DESIGN RECOMMENDATION MEETING - DPD# 3018112

6940 MLK JR WAY S.

07.14.2015

MERCY HOUSING
NORTHWEST

recommendation 2a

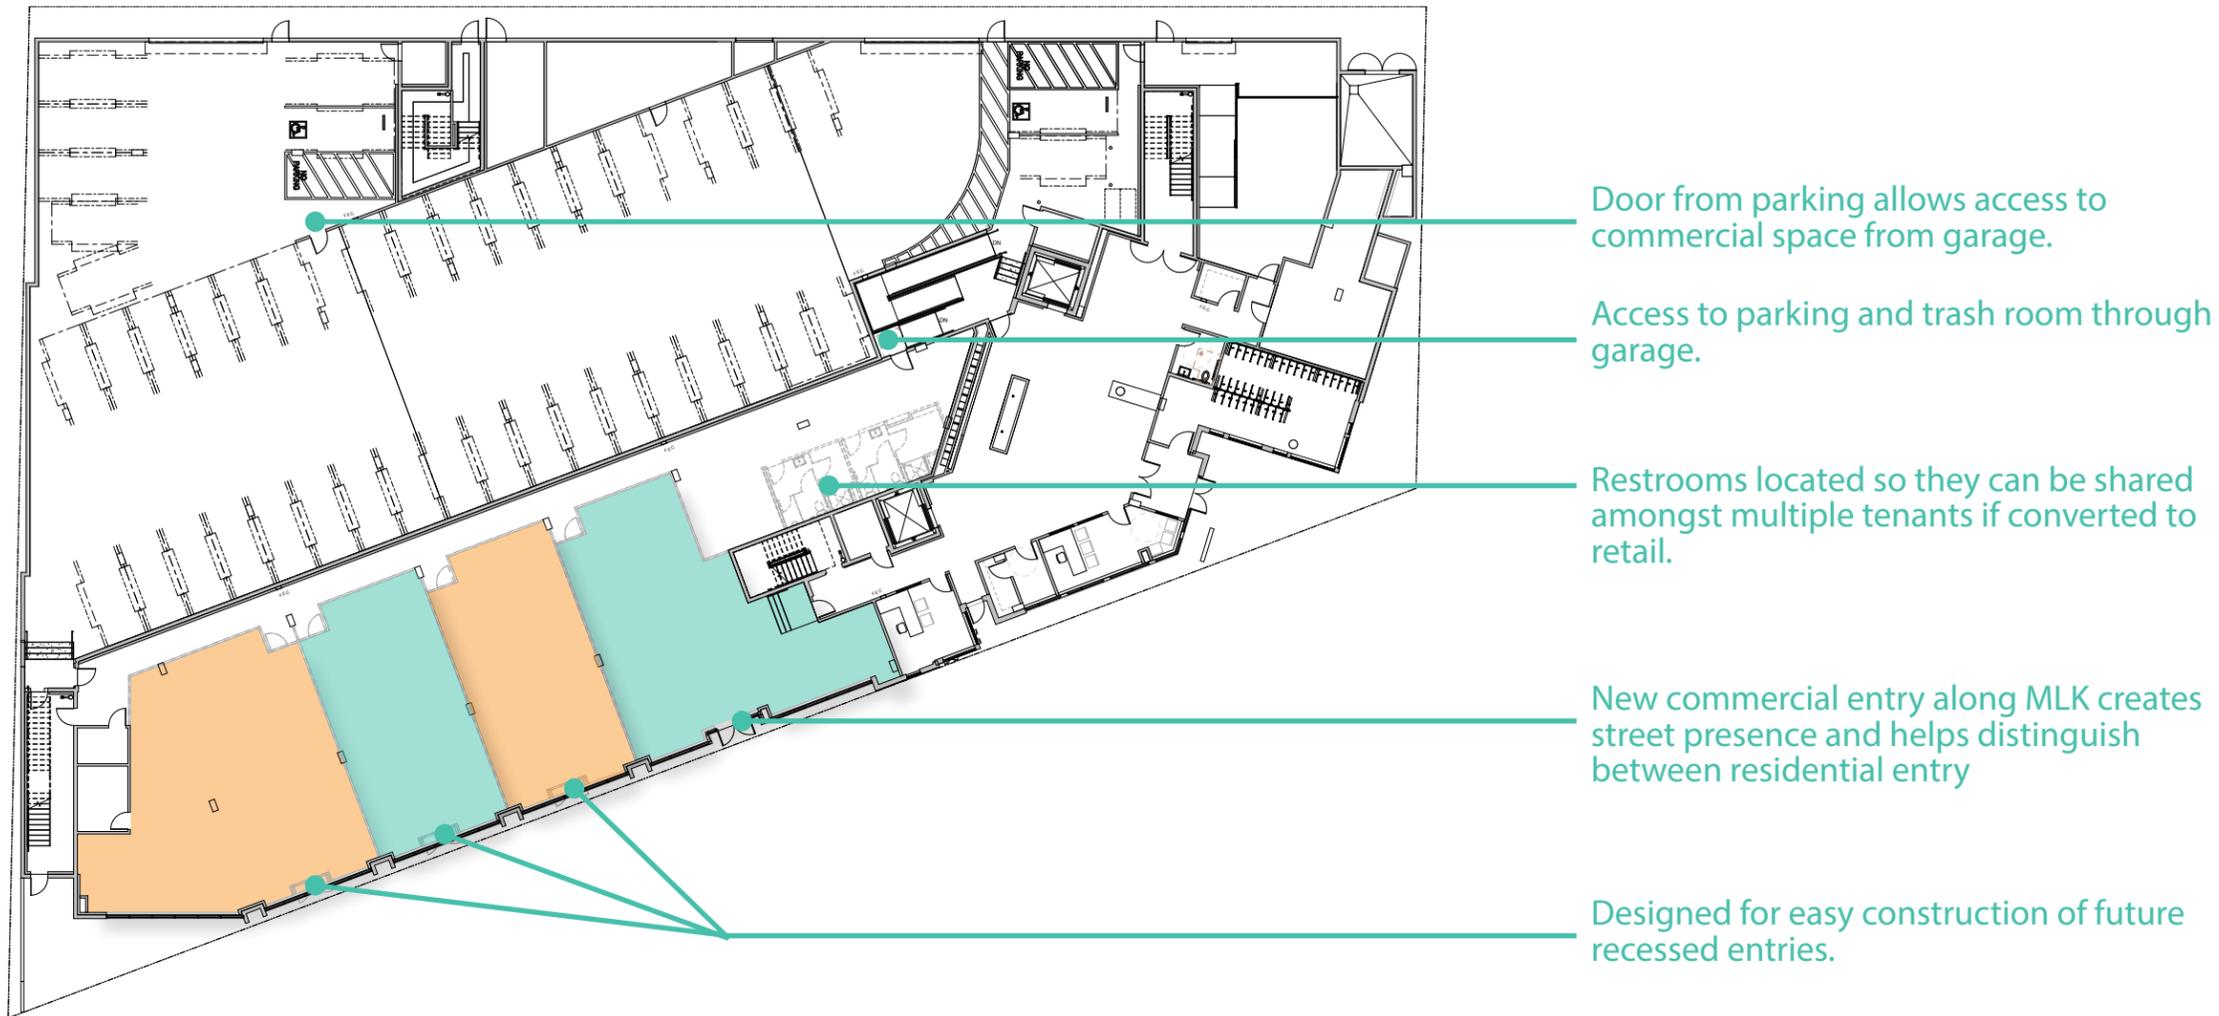
The Board requested that the ground-level commercial space be designed to be flexible so that it can be converted to retail use in the future as needed. The Board expects to see this guidance illustrated in a ground-level floor layout that clarifies the arrangement of interior spaces and accessibility to commercial parking and shared areas.

- new commercial entry off of MLK provides street presence
- design utilizes typical 24' bay language to provide flexibility for future retail
- access corridor along back edge creates easy traffic flow and access to parking and service spaces.
- sub-metering for future conversion to retail

recommendation 2b

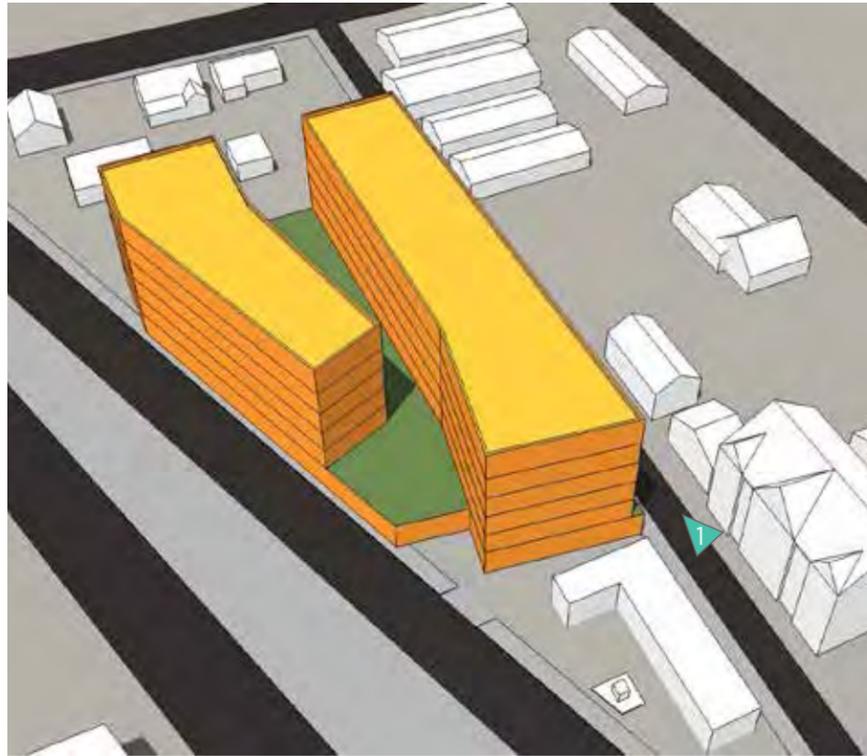
The Board stated that it is important that the main residential lobby entrance which may be utilized as a public entry be accessible and inviting. At the recommendation meeting, the board expect to review design elements that encourage interest at street-level and clarify building entries/edges.

- residential entry framed by vertical masses
- textured panels at entry provide finer grain texture and human scale.
- signage on canopy and at ground level aids in wayfinding.

recommendation 1a.i

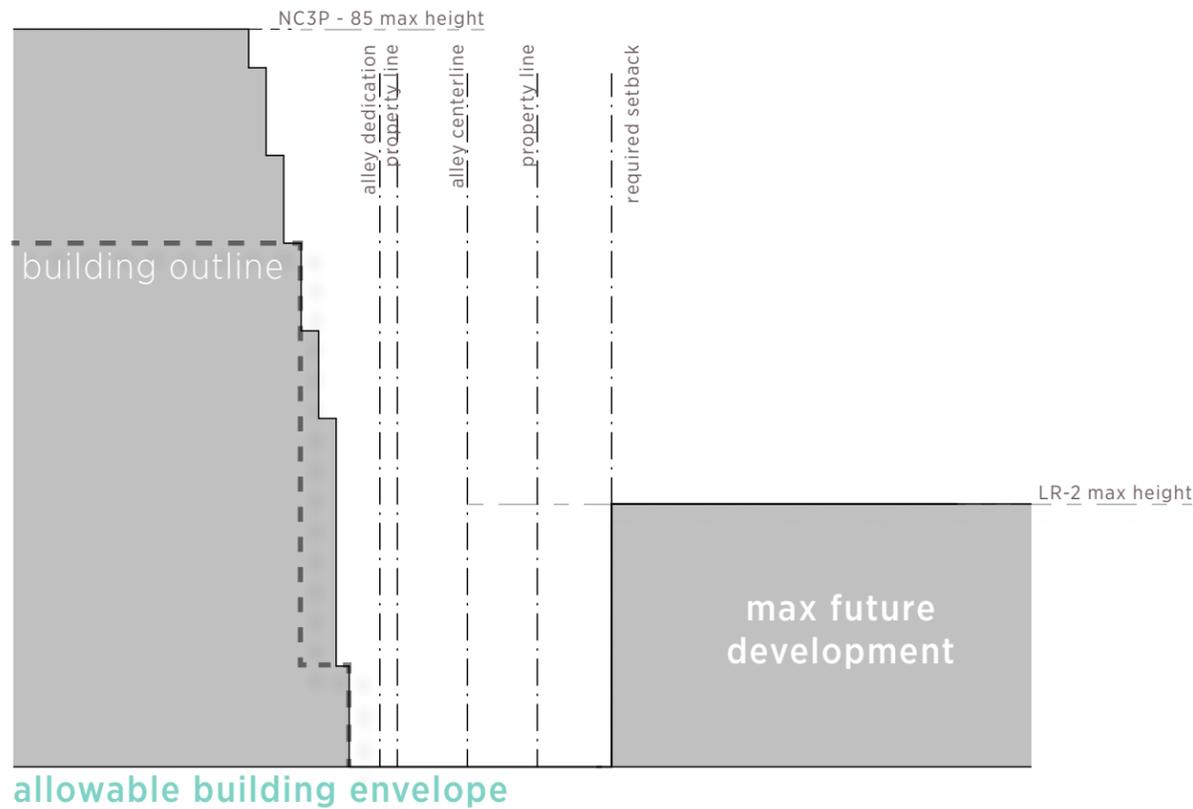
At the recommendation meeting, the Board expects to review detailed renderings that depict a design that includes more modulation applied to the eastern building mass in combination with effective use of secondary architectural elements to reduce the perceived massing.

- reduced massing by limiting height to 20' below the maximum allowed and increased setbacks above required.
- eastern facade broken down into three distinct buildings
- color, window patterning, and design language create visual interest and variety

recommendation 3a

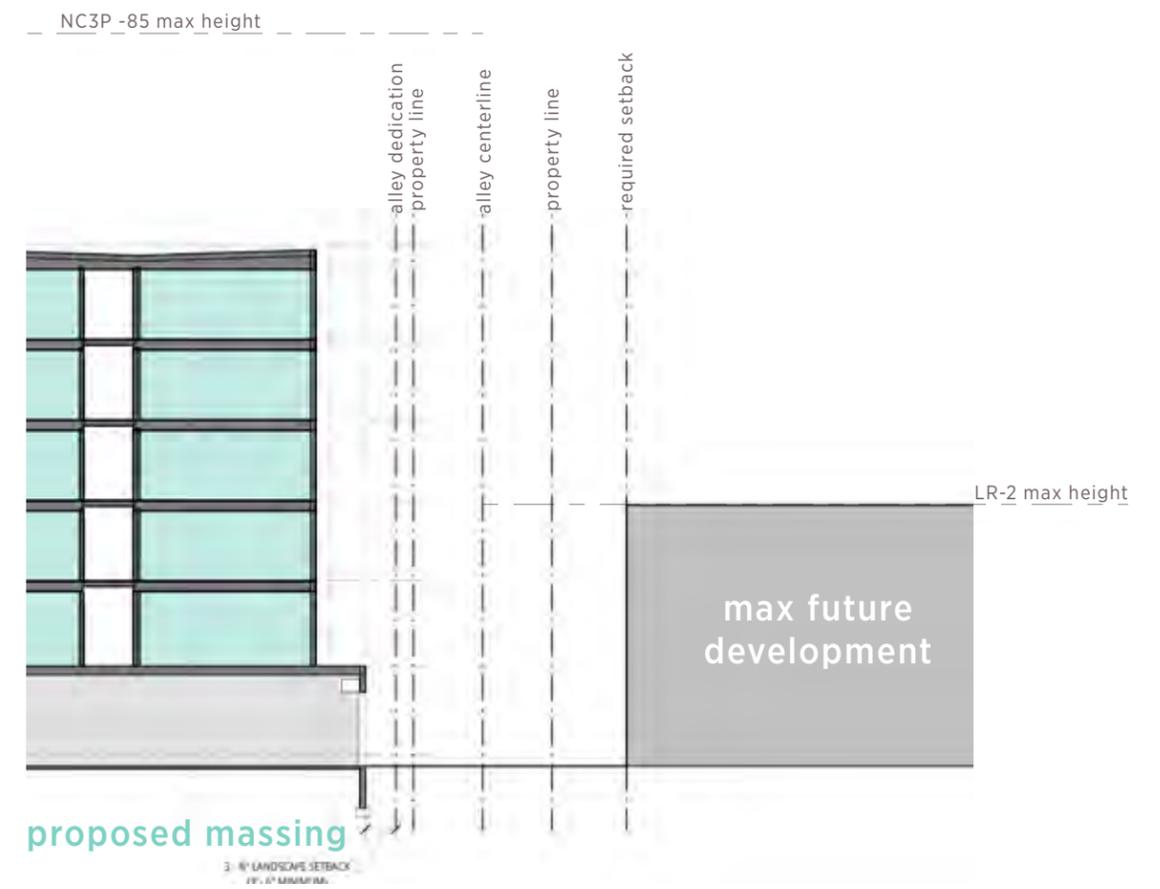
The Board requests further evaluation of the upper-level and ground-level east facades and design treatments that may dissipate perceived height, bulk and scale of the project in relation to the LR2 zone to the east.

The actual building height (60') is approximately 25' below where the zoning code maximum height. The anticipated height of future development on the east is 35' and the distance between the bodies of the buildings is anticipated to be 36'. The 1 to 1 ratio of the depth and the height of the future east facades allows light penetration and does not create a canyon effect within the alley.

At the ground level the east facade is identified as a single story as the mass of the upper levels is located about 6' to the west. Openings of various sizes and textures along the ground level east facade along with a green screen serve to further break down the scale and provide a soft transition to the street. The building mass being separated into 3 forms also creates forms of similar size as to what is anticipated on the east side.

recommendation 4b.ii

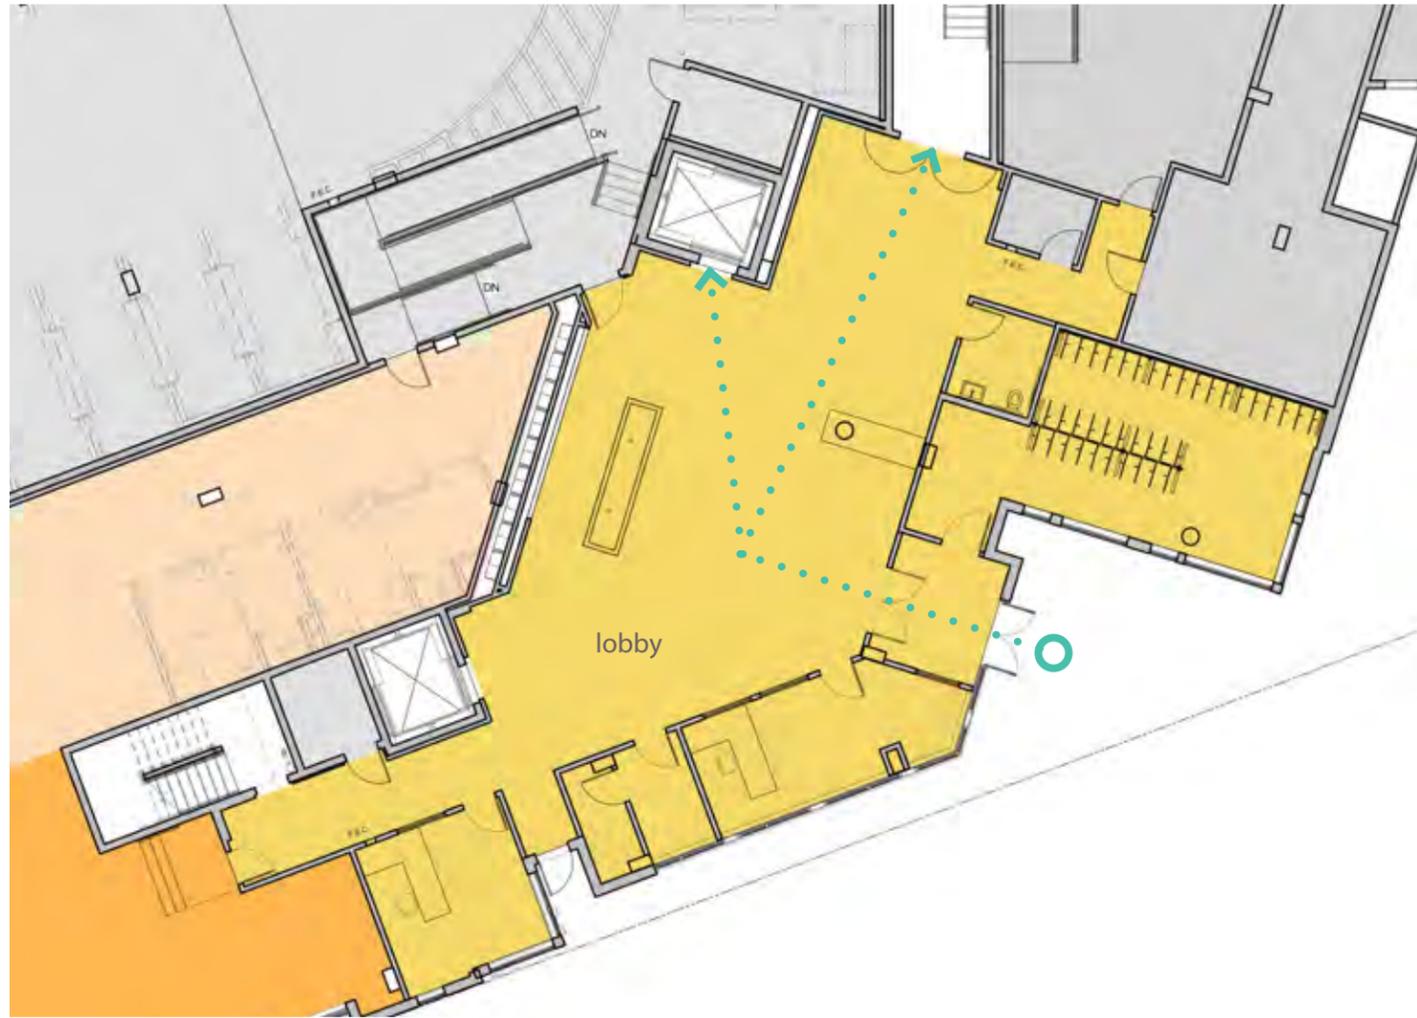
It is important that the Board understands the relationship between the project's plaza design concept and possible improvements at the Sound Transit property which may result in a larger plaza area

- entry plaza faces south and connects to the bus plaza. PL1.A.1
- the project works to replicate the paving pattern proposed by sound transit in their development of the adjacent site.
- landscaping helps to unite the two plazas and direct visitors toward the project entry.

recommendation 1a.ii

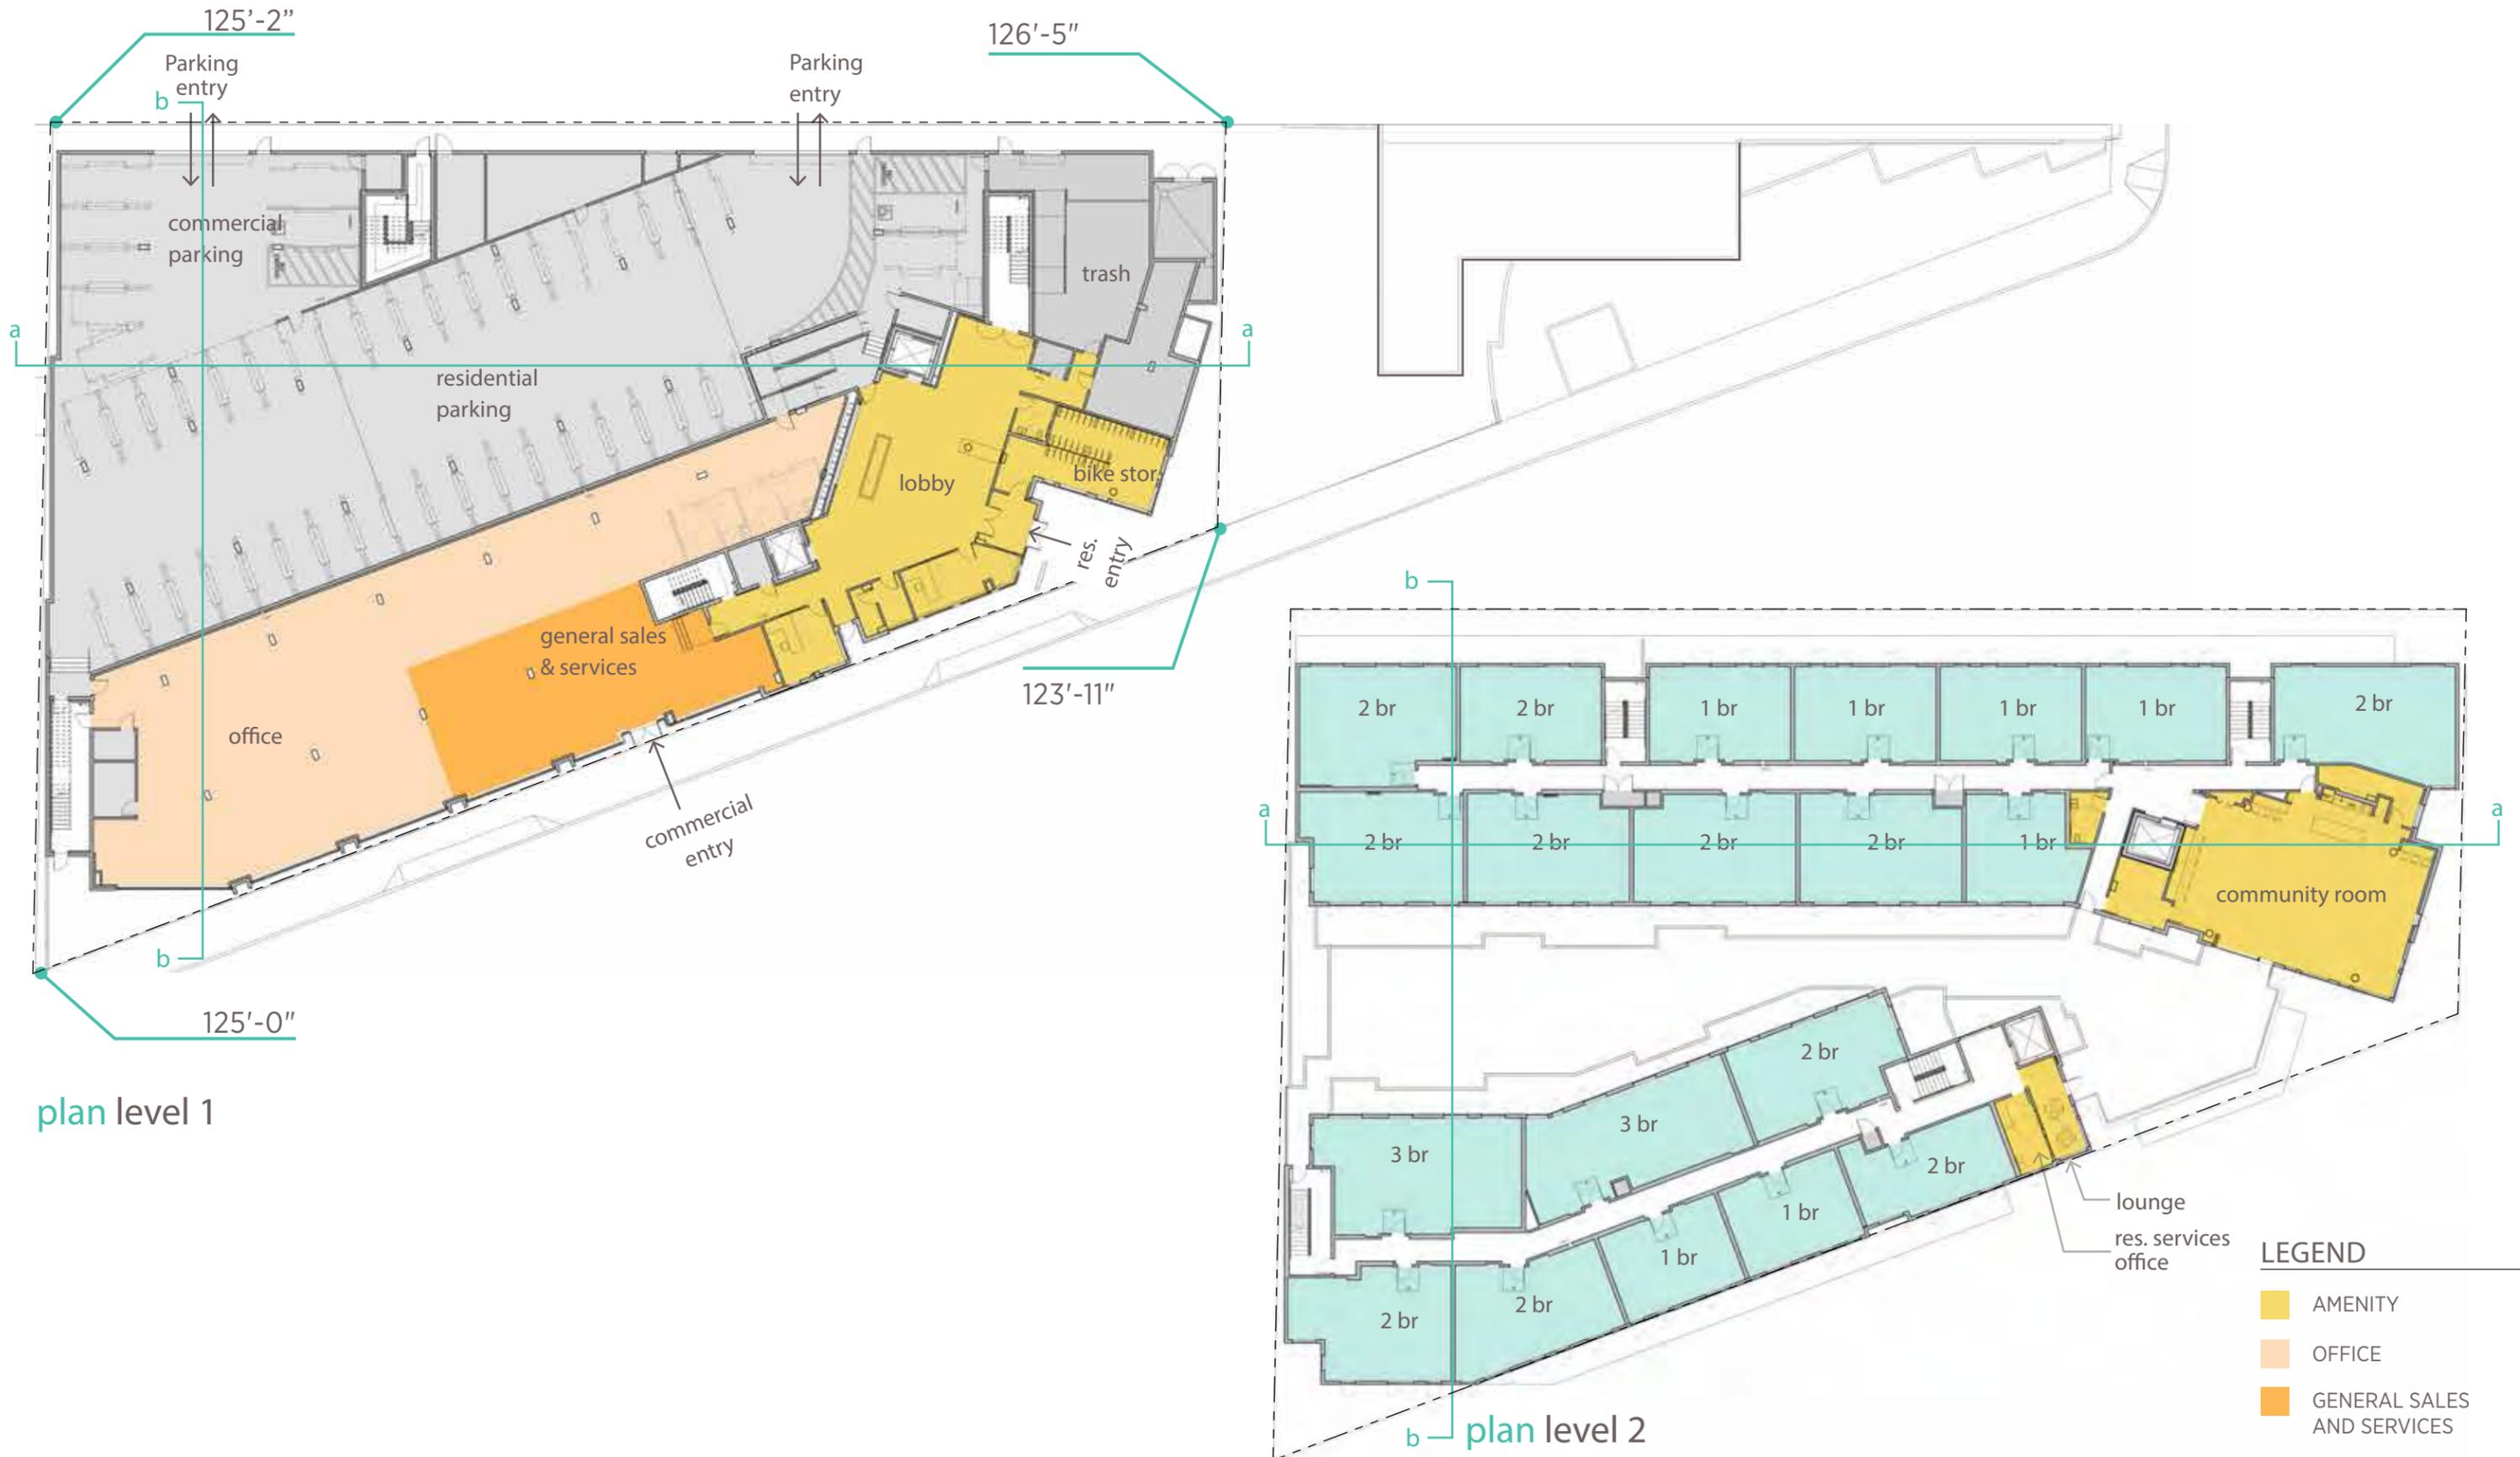
The Board identified areas between the proposed upper residential linear bar building masses that appeared to be narrow in width and commented that this need further exploration. The board requested information regarding the spacing daylight and shading impacts to the courtyard and residential units, and a better understanding of how the upper buildings will interact with one another be presented to the Board at the Recommendation meeting.

- area between buildings helps separate the more communal portion of the courtyard from the more private children's play area
- different angles between the two buildings creates oblique sitelines into adjacent units.
- courtyard is oriented north/south to maximize daylight
- light colored walls in courtyard bounce light deep into the space.
